**AFRICAN DEVELOPMENT BANK MANAGEMENT  
RESPONSE TO CRMU REQUEST FOR COMPLIANCE  
REVIEW AND MEDIATION FOR THE GIBE III  
HYDROELECTRIC POWER PROJECT, ETHIOPIA**

**April 2009**

## MANAGEMENT RESPONSE TO REQUEST FOR COMPLIANCE REVIEW AND MEDIATION FOR THE GIBE III HYDROELECTRIC POWER PROJECT (HPP)

**Figure 1: Monthly flows at Gibe III site: average 1964-2001**

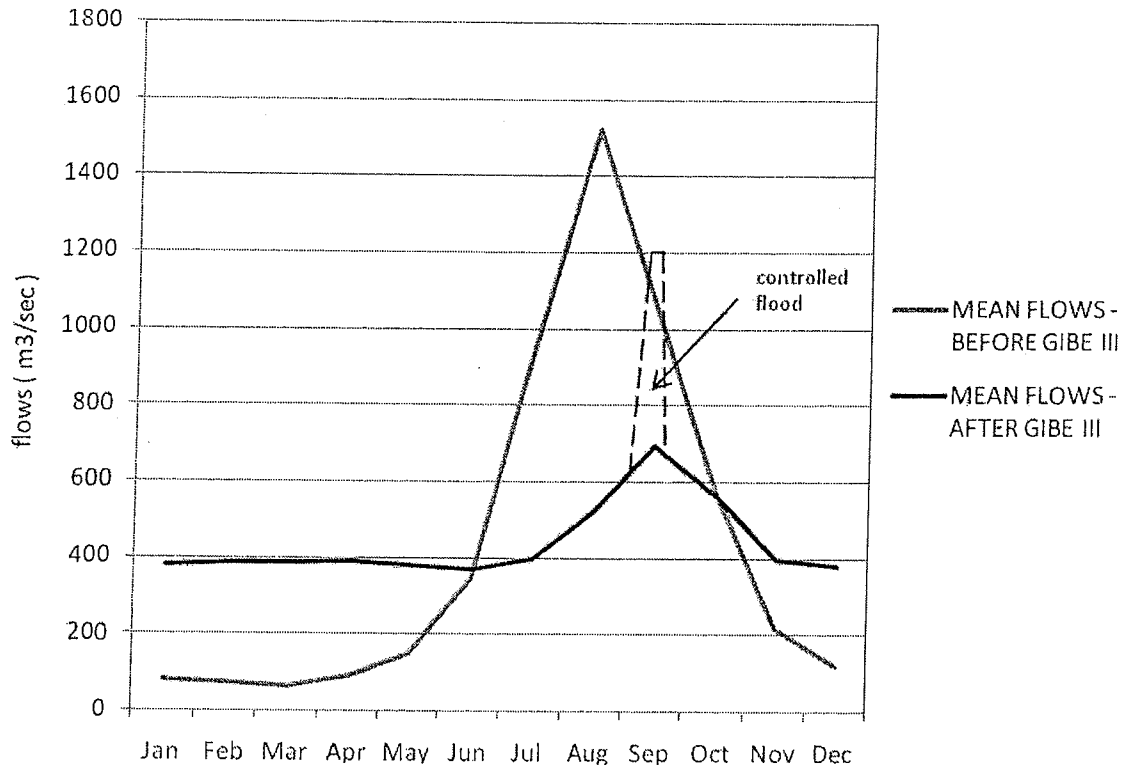
**4.2.1.1 Issue No.1a:** *The Gibe III Dam would have a serious impact on the flow and volume of the Omo River, which provides some 80% of the Lake's replenishing inflow. We (FoLT) have reviewed the Environmental & Social Impact Assessment, including the Additional Study of the Downstream Area, approved by the Ethiopian government in July 2008 and find these documents seriously flawed.*

*Indeed, the impact of Gibe III on Lake Turkana is barely acknowledged, and then only to be dismissed with spurious claims that the project will benefit the lake. These documents provide little scientific analysis regarding potential changes to the river flow, volume, (and Issue 1b chemical balance – discussed in Management response No.1b below). Analysis of the impacts of reservoir evaporation rates to downstream volumes also does not seem sound.*

**4.2.1.2** *No discussion of the duration or methodology of reservoir filling is provided. This could result in a prolonged dry season downstream, where the suggested environmental flow of 25m<sup>3</sup>/second, a rate equal to the single lowest monthly flow recorded in nearly four decades, could be implemented for well over a year. Such a potential experience could devastate the level of Lake Turkana.*

4.2.1.8 The following graphs illustrate the comparison between the monthly flows (at the Gibe III site) before and after the dam construction based on the most significant operating scenario envisaged. The analysis considers the discharges recorded during a 38 years period (1964 - 2001) simulating the operation of the plant.

4.2.1.9 Average flows during the month of August currently range from 820 m<sup>3</sup>/s to 2360 m<sup>3</sup>/s (Gibe III section, 38 years flow records). While operating the Gibe III plant the complete regulation of the downstream releases is allowed by the turbine outflows, up to a maximum of about 1000 m<sup>3</sup>/s, together with the large outlet works discharges.

**Figure 3: Monthly flows at Lake Turkana: average 1964-2001**

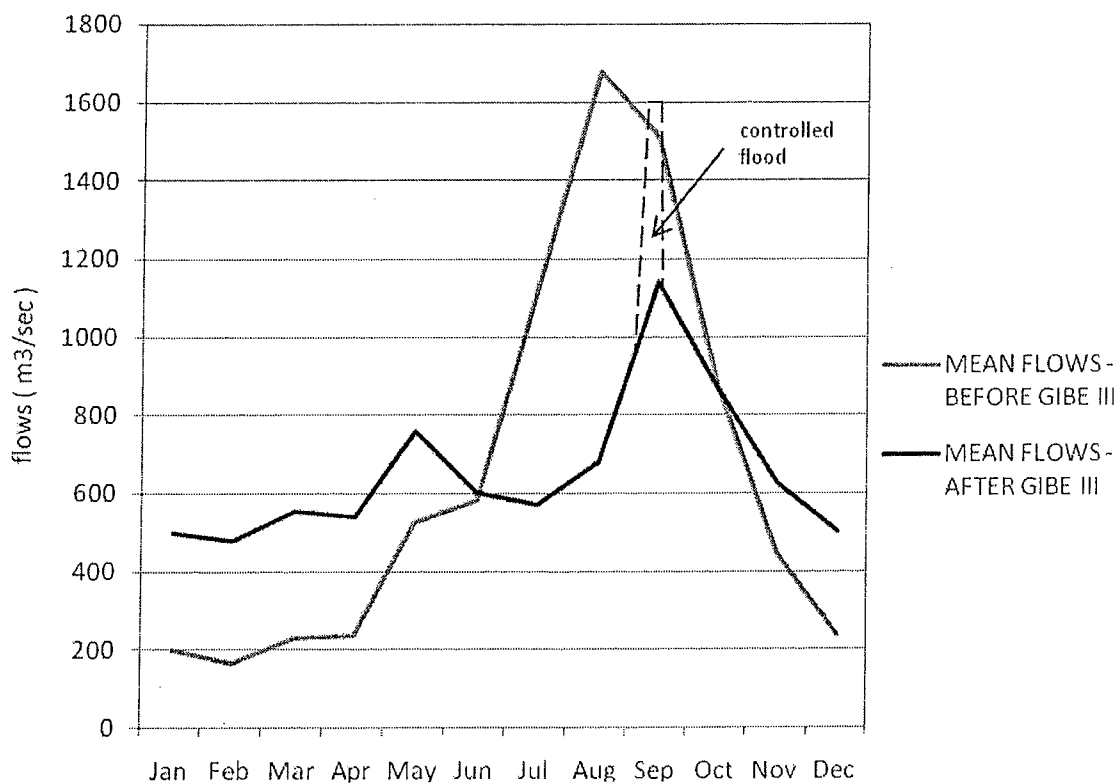
*4.2.1.3 A study by the Africa Resources Working group indicates that the completion of Gibe III could mean a drop in Lake Turkana's depth of between seven and ten meters. Resulting changes in the lake's chemical balance threaten the fish as well as other species (Nile crocodiles, hippopotamus, etc) that make Lake Turkana a valuable source of biodiversity.*

4.2.1.11 The graph below shows the average flows of the Omo River at Lake Turkana (38 years mean). The subsequent graph shows the minimum discharges of a highly dry year (1988).

The period corresponds to the last weeks of the natural hydrological floods and slightly varies each year depending on the contributions from the residual basin Gibe III - Turkana. The discharges are in the range of the monthly average natural flows at Turkana during the month of September ( $Q=1500 \text{ m}^3/\text{s}$ ) as illustrated in the Figure 3 above.

**Figure 5: Nutrients upstream and downstream Gibe I and at Gibe III (March 2008)**

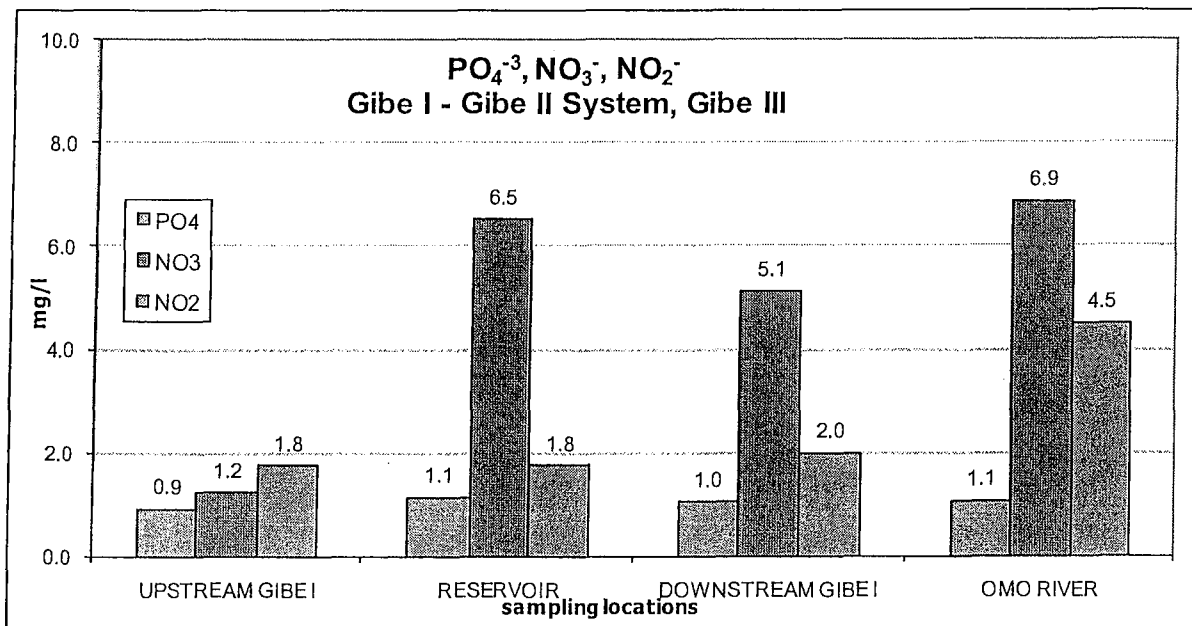
**Issue No. 1b:** *potential changes to the chemical balance due to reservoir evaporation*

4.2.2.1 The following graphs (Figure 5) indicate that measured BOD and COD values, while possibly reduced by the Gibe reservoir, do not substantially vary along the Omo River. The phosphorus content upstream and downstream the Gibe I reservoir is substantially unvaried and is by far lower than 20 mg/l which could be roughly considered a limit to consider the lake as "eutrophic". The nitrogen -while probably relevantly increasing within the Gibe I reservoir, also remains unvaried along the Omo River. The lake is probably "nitrogen-limited" considering this common indicator of the tropic status.

4.2.2.3 The phosphorus content upstream and downstream the Gibe I reservoir is substantially unvaried and is by far lower than 20 mg/l which could be roughly considered a limit to consider the lake as “eutrophic”. The nitrogen -while probably relevantly increasing within the Gibe I reservoir, also remains unvaried along the Omo River. The lake is probably “nitrogen-limited” considering this common indicator of the trophic status.
